P 531932

A REPAIR

ON-SITE SEWAGE DISPOSAL SYSTEM HOWARD COUNTY HEALTH DEPARTMENT BUREAU OF ENVIRONMENTAL HEALTH

SUBDIVISION: Big Branch Overlook LOT NUMBER: 42

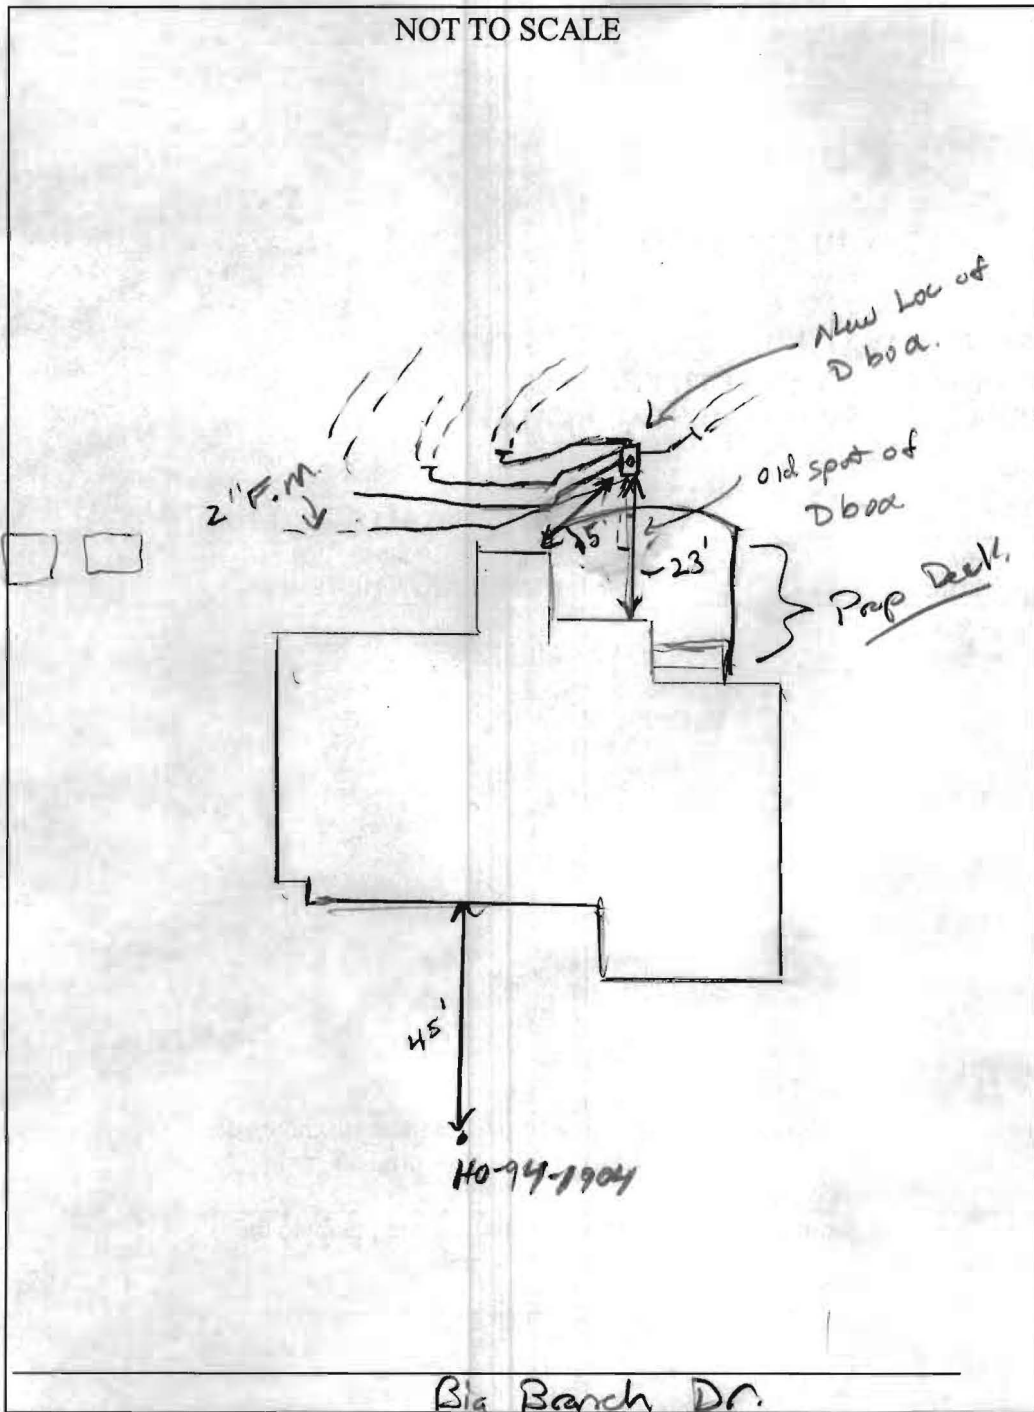
TRENCHES:	Trench to be feet wide. Inlet at feet below original grade. Bottom maximum depth feet below original grade. Effective area begins at feet below original grade. feet of stone below the distribution pipe.
LOCATION:	In support of Building Permit for a deck, D-Box to be moved and piping to the trenches adjusted. Call for inspection when ground is opened.
ADDITIONAL NOTES:

INSTALLATION 10/7/09 Contractor exposed D box, F.M. and dist. network. Proposed Deck marked off in field. Re-locate D box ~ 5' downhill and re-plan dist. network and F.M. (150)

10/7/09 (2:30 PM) D box moved ~ 45' away from here. F.M. re-routed out of way from proposed Deck. Dist. network re-routed away from proposed Deck area. (150)
